PCN	Product Change Notification	De-23-08-0709	
Product	MicroSpeed	Date of Publication:	
		11.08.2023

Title: Update of customer drawing microspeed

Detail X
M 20:1 / scale 20:1

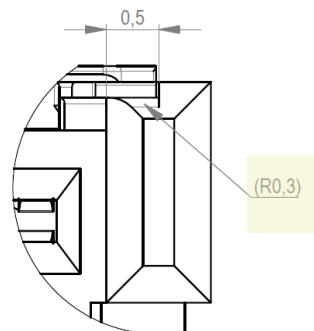
Valued customer,
we updated Microspeed drawings to the real state of parts (524539-E) and set dimensions in brackets, as they already were defined in the component drawing (374720-E; 284310-E). You can find the changes marked yellow in the pictures below.
